HISTORIC AND DESIGN REVIEW COMMISSION

HDRC CASE NO: 2021-579
ADDRESS: 209 CEDAR ST
LEGAL DESCRIPTION: NCB 933 BLK 5 LOT S IRR 77.36 FT OF N 140.64 FT OF 1
ZONING: RM-4,H
CITY COUNCIL DIST.: 1
DISTRICT: King William Historic District
APPLICANT: Alberto Gonima
OWNER: Alberto & Maria Gonima
TYPE OF WORK: Installation of a freestanding gazebo structure
APPLICATION RECEIVED: November 02, 2021
60-DAY REVIEW: Not applicable due to City Council Emergency Orders
CASE MANAGER: Stephanie Phillips
REQUEST:

The applicant is requesting a Certificate of Appropriateness to install a freestanding gazebo structure with a footprint of 168 square feet in the side yard.

Proposed Gazebo Location -
209 Cedar St.

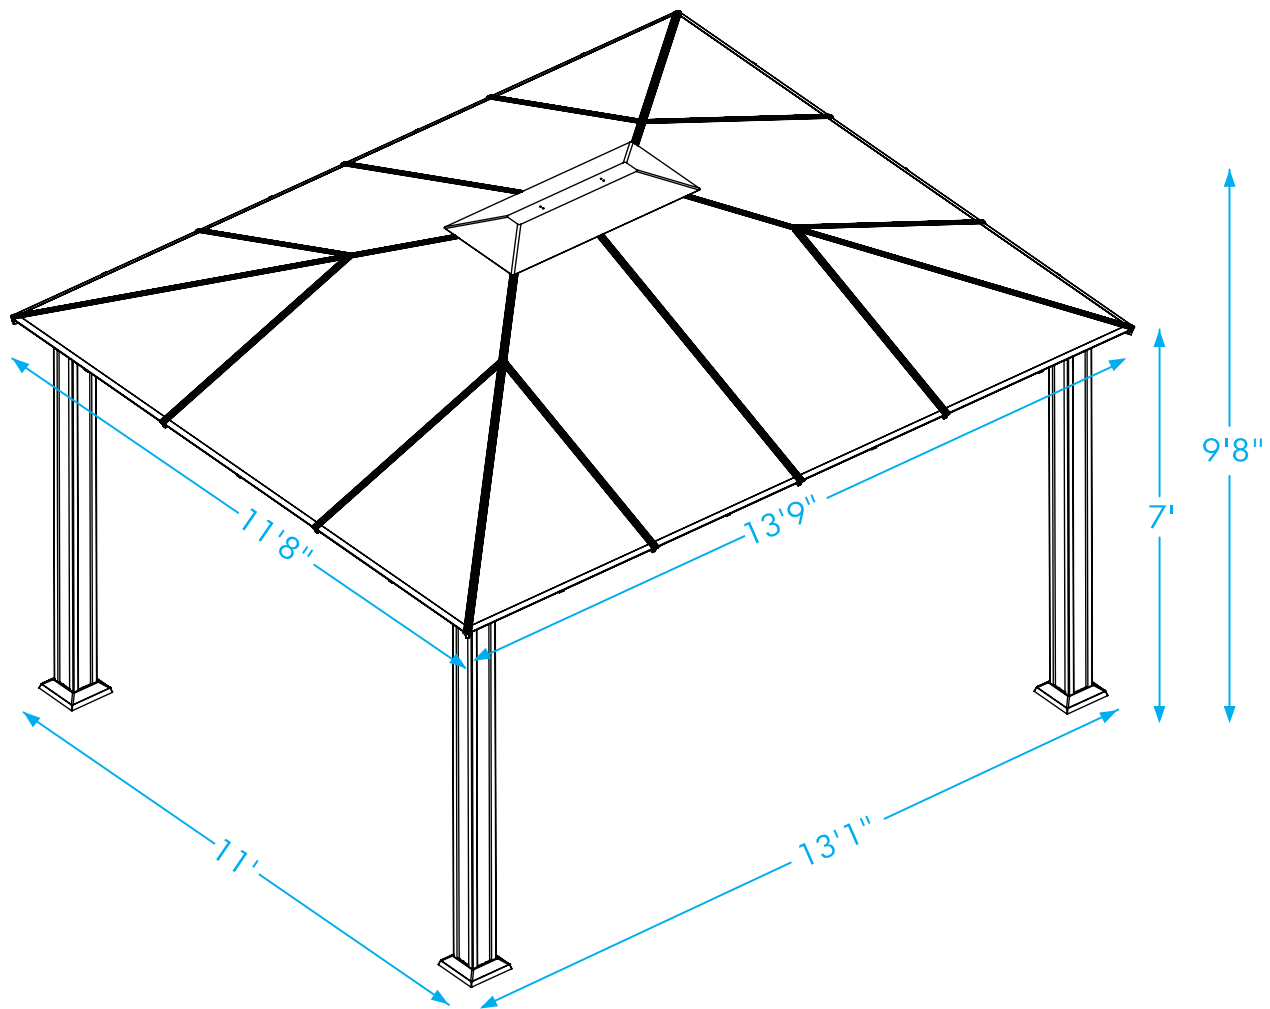
- c. **ORIENTATION AND SETBACK** – The applicant has proposed to install a freestanding gazebo structure in the side yard. Per the Guidelines, new outbuildings should be located at the rear of the lot whenever possible and should be inset behind the front façade to minimize the impact on the public streetscape. This lot is unique in siting and configuration and effectively does not have a backyard. With these limitations, staff finds that a freestanding structure may be appropriate in the side yard, but finds that the structure should be set back behind the front plane of the house to minimize its impact on the public right-of-way.

- i. That the structure be set behind the front plane of the primary historic structure. An updated site plan is required to be submitted to staff for review and approval prior to the issuance of a Certificate of Appropriateness.
